P/V Stimson Shipyard Repair

ITB 2025-1200-0074

Amendment # 2

October 7, 2025

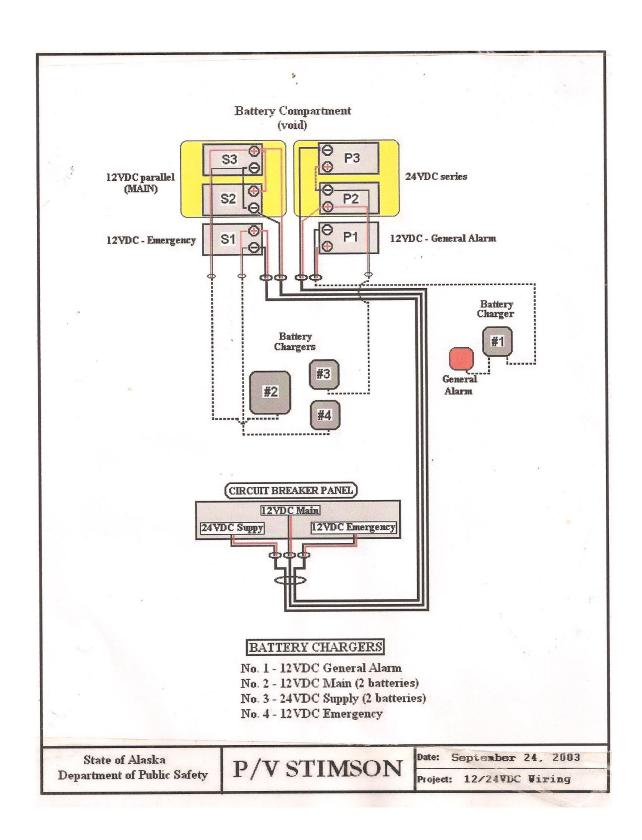
Question 4: Section 4.3 INSTALL CROWS NEST FOR AFT MAST – The existing aft mast has been deemed unsafe for crew maintenance of electronics and navigational lighting. Vessel Captain request that the mast area be made more accessible by lowering and /or installing a small working platform.
The Contractor can only provide a Rough Order of Magnitude price for this item for the reasons listed below:

- The Specification states that the final design is to be made on scene with Captain and yard personnel
- Lack of as build drawings of the existing mast.
- Crows Nest is a Personal Safety item should be engineered and approved.
- Relocating navigation lights required approval and an updated drawing.

<u>Answer:</u> Contractor is expected to provide safe marine grade engineered design to Captain for approval. Please see S-23 Main Mast details for existing structure.
